SUBJECT: H. B. ROBINSON STEAM ELECTRIC PLANT UNIT 2 - ISSUANCE OF REQUEST FOR ADDITIONAL INFORMATION ON INDIVIDUAL PLANT EXAMINATION OF EXTERNAL EVENTS (IPEEE) FOR SEVERE ACCIDENT VULNERABILITIES, 10 CFR 50.54(F) (TAC NO. M83688)

Robinson 2 IPEEE Supplemental Request for Additional Information Related to Postulated Seismic Events

**SUPPLEMENTARY
TECHNICAL EVALUATION REPORT
BASED ON THE
SITE VISIT AND STEP-2 REVIEW OF THE
INDIVIDUAL PLANT EXAMINATION OF EXTERNAL EVENTS SUBMITTAL
FOR THE
H. B. ROBINSON (UNIT 2) PLANT**

FINAL DRAFT REPORT

Figure 1 Relationships Between Moment Magnitude and Various Magnitude Scales (After Heaton *et al*, 1984)

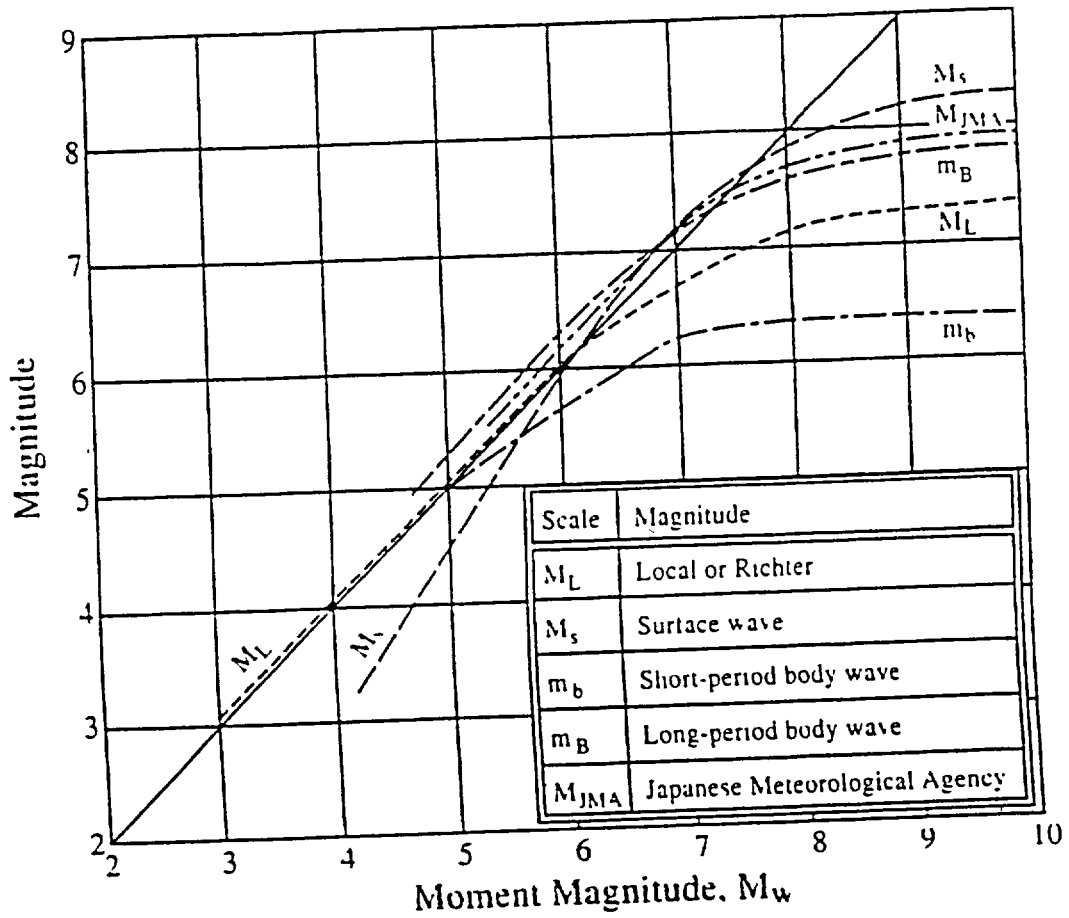
The result that a short period body wave magnitude value of 5.9 m_b corresponds to a (smaller) moment magnitude of 5.5 M_w is opposite to that which would result from commonly-used conversion relations. Figure 1 shows a plot of the relationship between the moment magnitude M_w and other magnitude scales due to Heaton *et al.* (1986, Reference 17) which is recommended by the 1997 NCEER Workshop Proceedings and also presented in Earthquake Hazard Analysis: Issues and Insights, by L. Reiter, 1990 (Reference 18). This figure shows that, for all moment magnitudes greater than 5.0 M_w , the moment magnitude M_w is greater than the corresponding short period body wave magnitude m_b . From this figure, a short period body wave magnitude of 5.9 m_b corresponds to a moment magnitude of 6.3 M_w .

Figure 6 Comparison between Robinson IPEEE Fines Content (FC) corrected blow counts and those using Seed and NCEER correction models

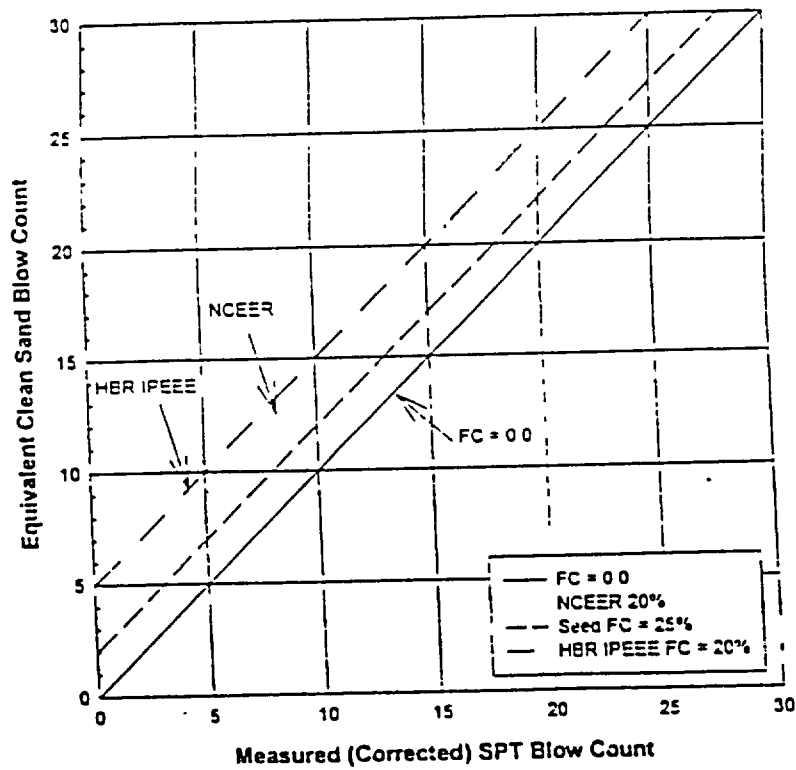
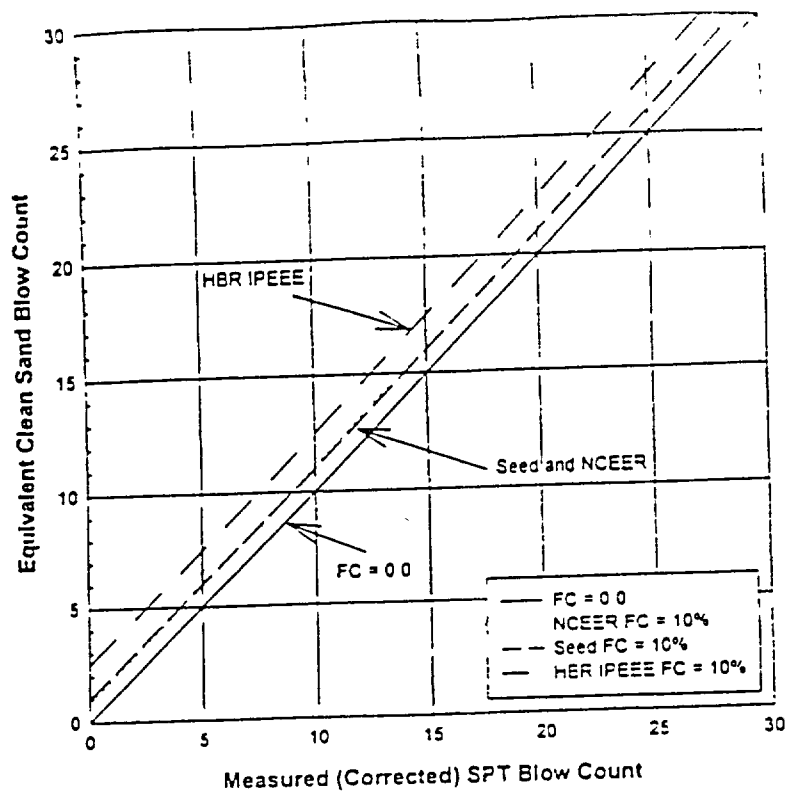
A comparison of the equivalent clean sand blow counts given by the Seed correction model, the 1997 NCEER Workshop Proceedings correction model, and the model used by CP&L is shown on Figure 6. It can be seen that the values used for Robinson are somewhat higher than those of Seed and NCEER at a fines content of 10%, but the values are close to those of NCEER at a fines content of 20%. Thus the Robinson equivalent clean sands blow counts are somewhat non-conservative with respect to the other two models, especially for measured blow counts less than 10 (which is when liquefaction might be expected).

Figure 7 Magnitude Scaling Factors Defined by Various Investigators

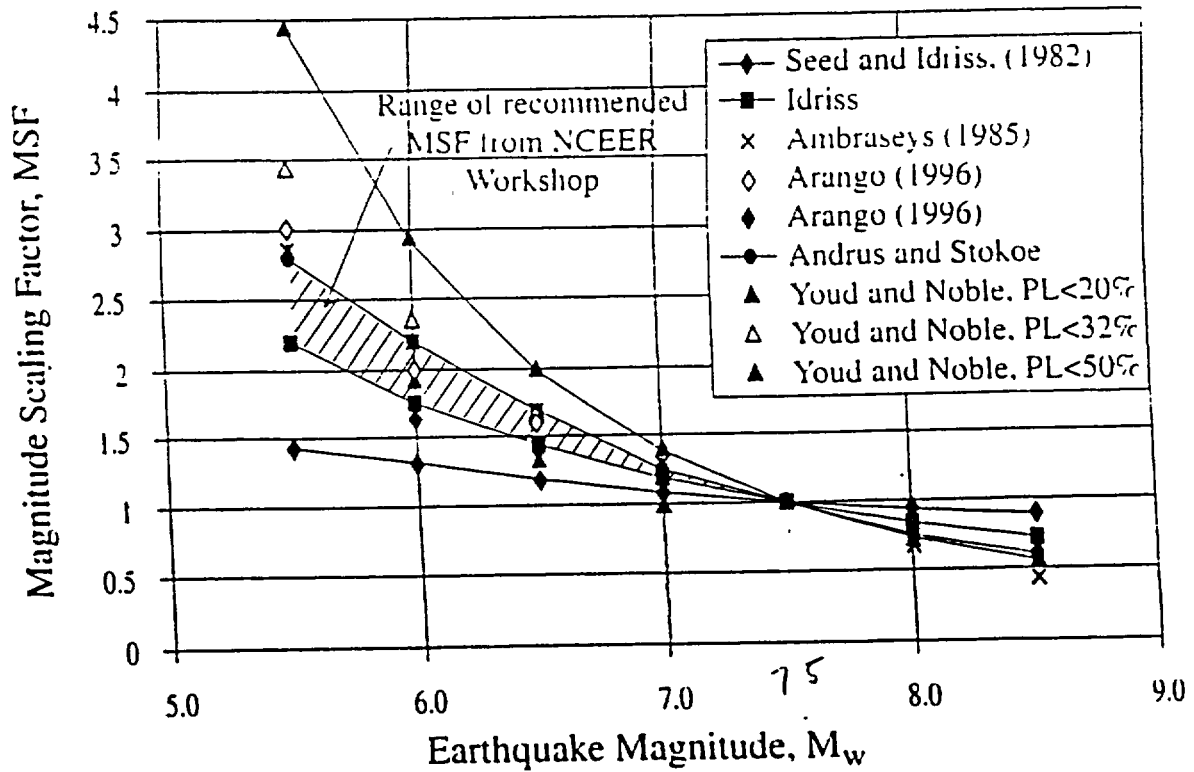
This recommended range of values is shown (cross-hatched) on Figure 7 (taken from the 1997 NCEER Workshop Proceedings).

The Youd and Noble (1997) magnitude scaling factors given in Table 1 are also plotted on Figure 7. It can be seen that all the (probabilistically-based) MSF values of Youd and Noble fall in a range significantly above the recommended range of magnitude scaling factors. Use of ~~the~~ either the Loertscher and Youd (1994) or the Youd and Noble (1997) values will significantly lower the liquefaction demand parameter CSR (since the correction for different magnitudes is obtained by dividing the computed CSR value by the magnitude scaling factor) and thus predict significantly less liquefaction at the H. B. Robinson site.

Figure 8 Plot of Robinson-Unit 2 Site Measured (Corrected) Blow Count data and Blow Count Boundaries for No Liquefaction Based on CP&L IPEEE, EPRI and 97NCEER Magnitude Scaling Factors

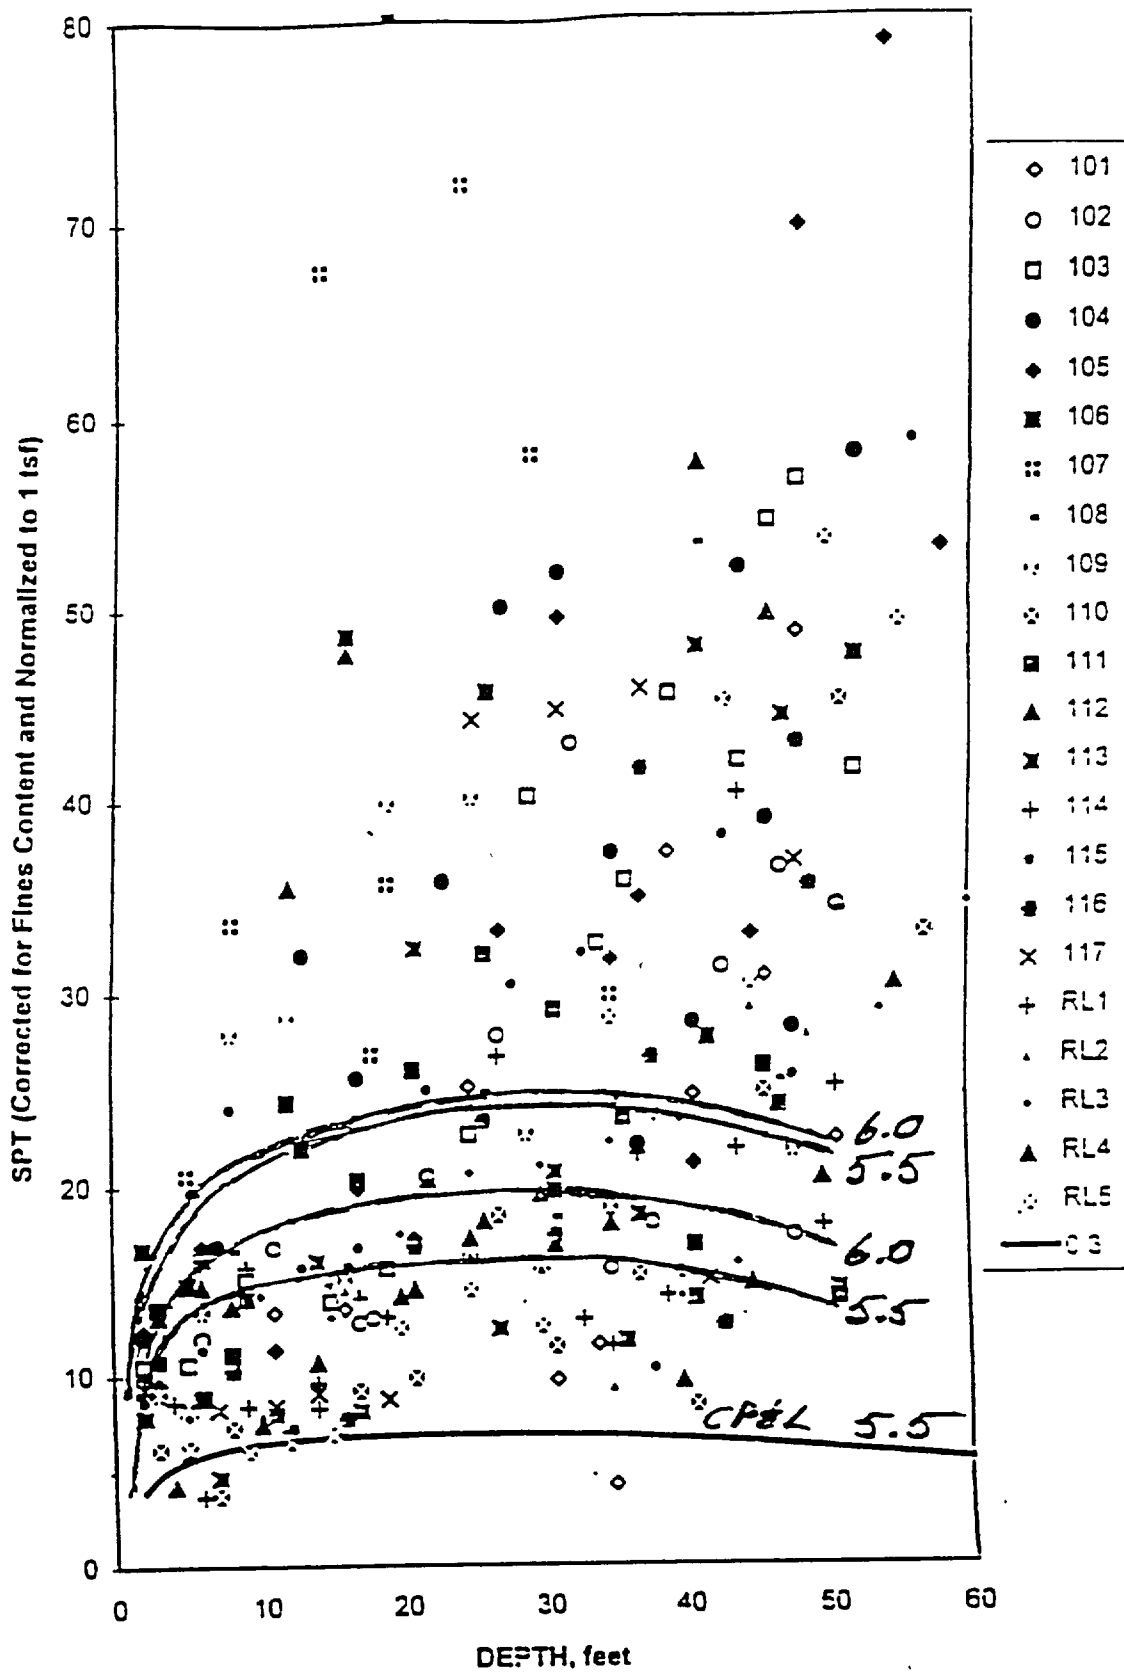
Figure 8 is a copy of the CP&L liquefaction results presented in support of the H. B. Robinson IPEEE based on the site borings made during plan design and construction. The lowest curve on this figure denotes the liquefaction/no liquefaction boundary obtained by CP&L based on a magnitude of 5.5 M_w and (evidently) assumed uniform values of soil density and water table depth (values not provided). The data points plotted vs. depth are the corrected SPT blow count values for clean sands normalized to 1 tsf. In this plot, data points lying below the boundary line correspond to points of potential liquefaction.

For comparison, I have added four lines to this CP&L plot. The top two curves give the liquefaction/no liquefaction boundaries obtained using the Seed and Idriss (1982) magnitude scaling factors for earthquake magnitudes 5.5 and 6.0 M_w . (These are the boundaries obtained if the EPRI 6041 approach is followed.) The middle pair of curves give the liquefaction/no liquefaction boundaries based on the Idriss (revised) magnitude scaling factors for earthquake magnitudes 5.5 and 6.0 M_w . (These are the boundaries obtained using the lower bound magnitude scaling factors recommended by the participants in the 1997 NCEER Workshop Proceedings.) As can be seen, for either the boundaries based on the EPRI 6041 MSF values or the boundaries based on the 1997 NCEER Workshop Proceedings recommended MSF values, many of the CP&L measured SPT blow count points would fall below the boundaries, and thus would be points of predicted liquefaction. This is true at either magnitude 5.5 or 6.0 M_w , although, of course, more points of liquefaction are predicted with the magnitude 6.0 M_w curves.

In regard to Table 2 and Figure 8, it should be noted that, regardless of the measured blow counts, liquefaction will not occur in a soil layer that is inherently not susceptible to liquefaction. That is, some of the points showing a measured blow count less than the blow count required for no liquefaction are not, in fact, indicative of liquefaction. This is because the soil layer in which the blow count was taken consists of clay or gravel (or a sufficient mix of sand, clay and/or gravel) so as not to be liquefiable.

Figure 9 Volumetric Strain versus Cyclic Stress Ratio and Modified Blow Count (from Ref. 10 after Ref. 25)

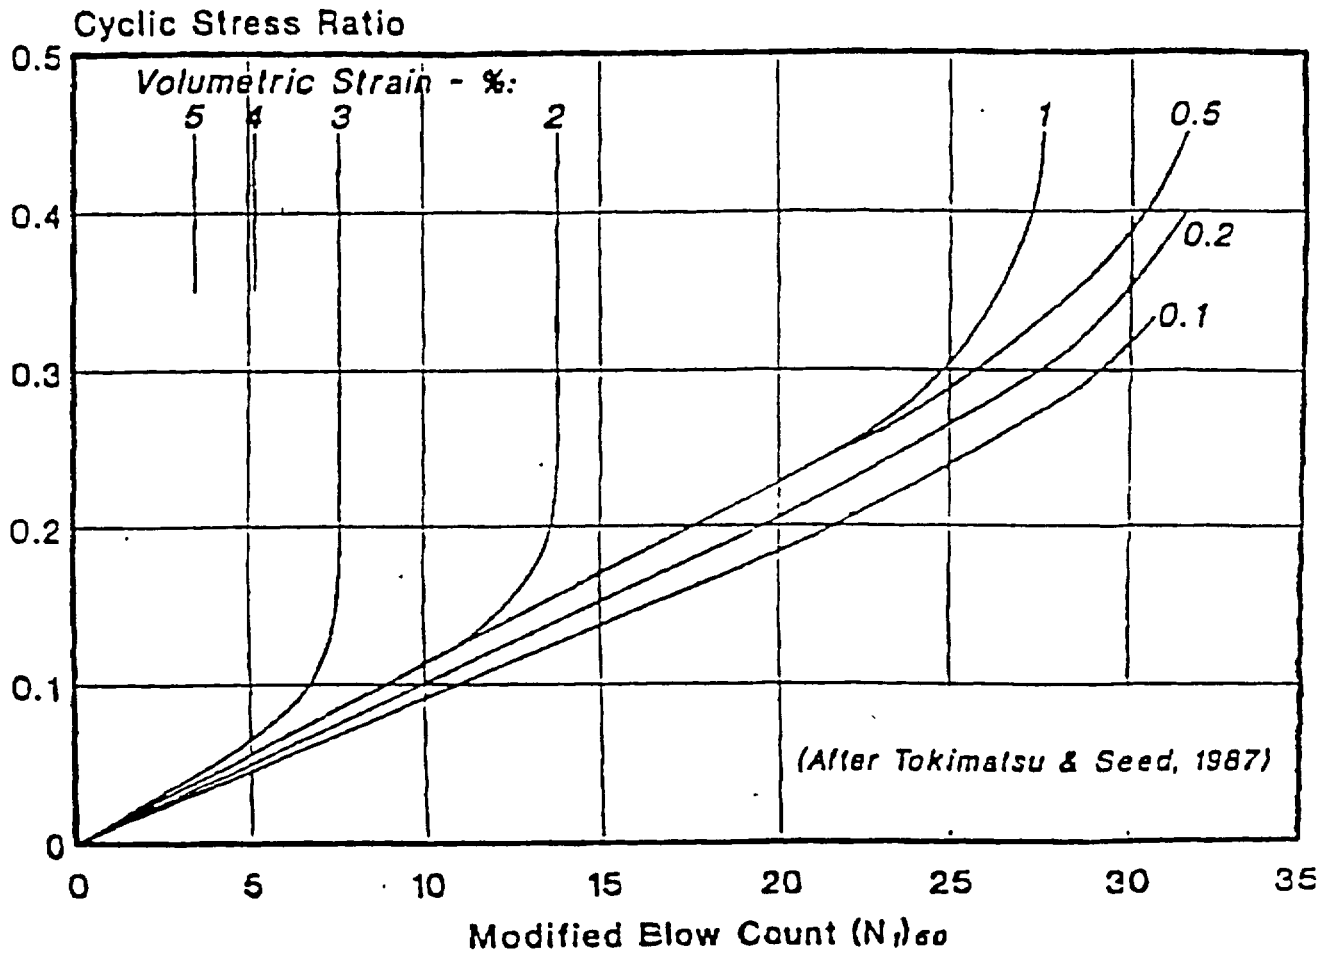
However, using the data in Table 2 (assuming a water table depth of 2 feet and a soil density of 118.5 pcf) and a particular choice of magnitude scaling factor, one can compute the soil settlement using the volumetric strains from Figure 9. The details of these calculations are given in the tables in Appendix B, and the results [based on the magnitude scaling factors given by the lower bound recommendations of the 1997 NCEER Workshop Proceedings (ie., MSF = 2.2 for 5.5 M_w and 1.76 for 6.0 M_w)] show the following displacement estimates:

Figure 10 Estimation of Volumetric Strain Based on Factor of Safety Against Liquefaction and Relative Density (from Ref. 10 after Ref. 26)

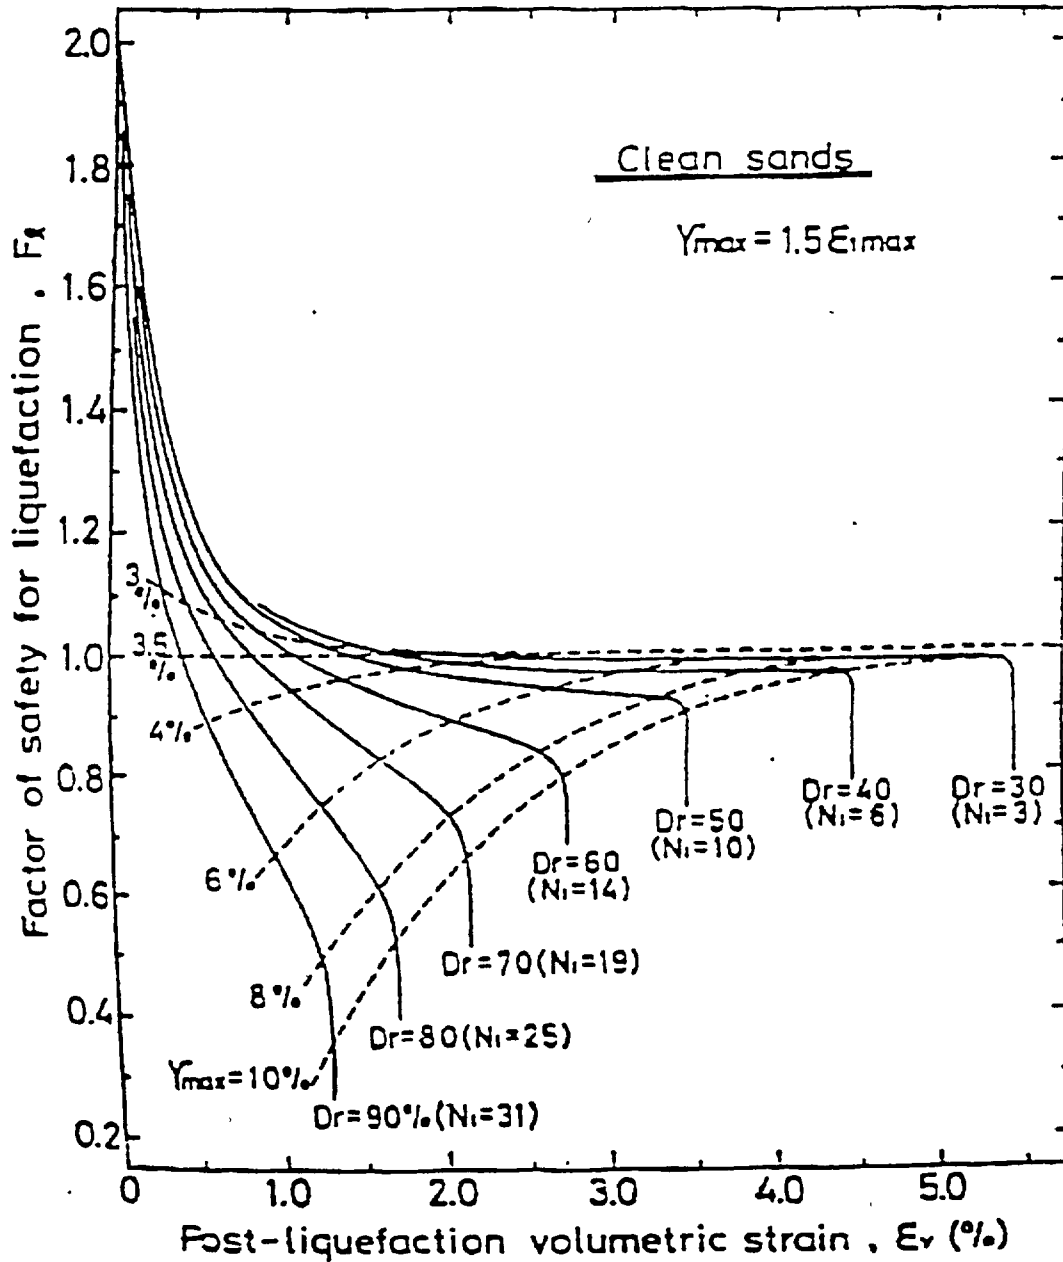
2. Second, and more importantly, the CP&L assumption that liquefaction will not occur has contaminated their argument. As they state, the 2% volumetric strain value was taken from Figure C-18 in EPRI-6041. This figure is reproduced herein as Figure 10 (and is essentially a re-plot of Figure 9). As they state, the 2% volumetric strain value corresponds to an assumed margin of safety against liquefaction of 1.0 and a blow count of 10. Thus they have assumed that, at worst, only incipient liquefaction might occur (which, of course, is based on their non-conservative choice of magnitude scaling factors as discussed previously). Referring back to Figure 8 (this report), it can be seen that the margin of safety against liquefaction will be significantly less than 1.0 for many locations in the site soils when either the EPRI-6041 magnitude scaling factors or the 97 NCEER magnitude scaling factors are used in computing the liquefaction potential. Thus, as can be seen from Figure 10, for those soil layers having factors of safety from 0.80 to 0.95 and corrected blow counts between 6 and 10, the actual volumetric strains implied by this figure are 3–4.5%. Hence the CP&L computed value of maximum soil displacement under the piping system (4.3 inches) is undoubtedly too low by at least 50% and perhaps up to 150%. Such displacements would significantly exceed the allowable support displacement quoted by CP&L.

Conclusion: The performance of the buried piping associated with the diesel fuel and primary water systems should be reexamined (using nearby SPT bore hole test data) basing the prediction of liquefaction-induced displacements on a magnitude range of 6.0–6.5 M_w and the more realistic magnitude scaling factors recommended by the 1997 NCEER Workshop Proceedings as discussed above.
